Planning Commission Staff Report

Project Type: Residential Addition

Location: 14968 Chateau Village Drive (Chateau Village)

Description: **14968 Chateau Village Drive:** A request for a residential addition for an existing home zoned "R2" Residence District located at 14968 Chateau Village Drive in the Chateau Village subdivision (20S340490).

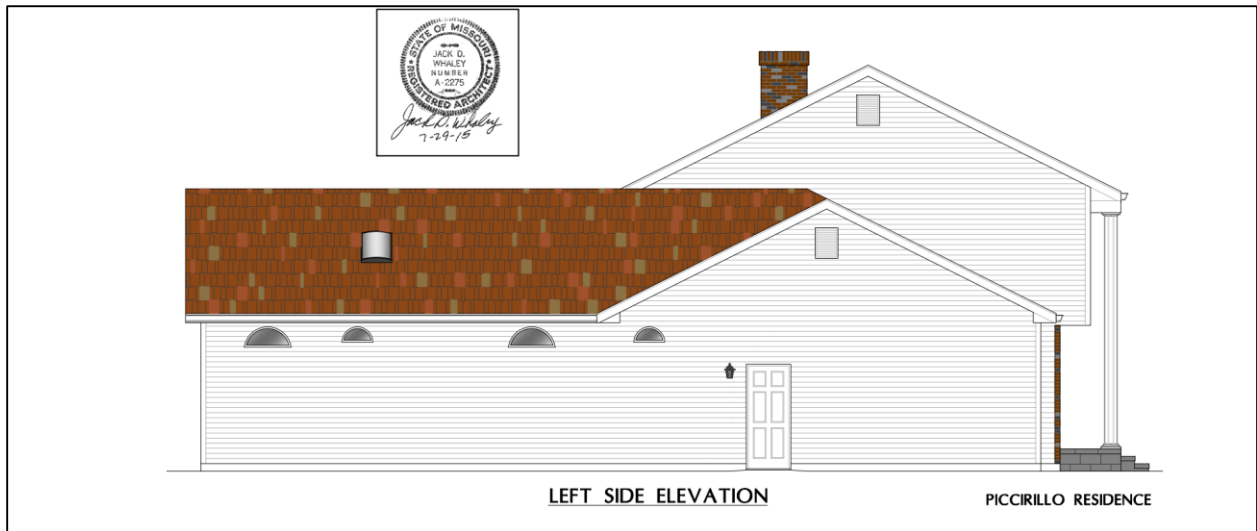
The applicant is proposing the reconstructed garage would not include the brick veneer that currently exists on the garage and first floor of the home. Instead, the primary material on the front garage elevation will be the decorative carriage-style garage door with vinyl siding to match the remainder of the home as the secondary material, see Figure 3 on page 3. The living space addition is primarily to the rear of the structure behind the reconfigured garage with little to no public view from the street frontage. Below in Figure 4 and 5 are side and rear elevations of the living addition. The overall maximum height of the home will not be changed by this addition.
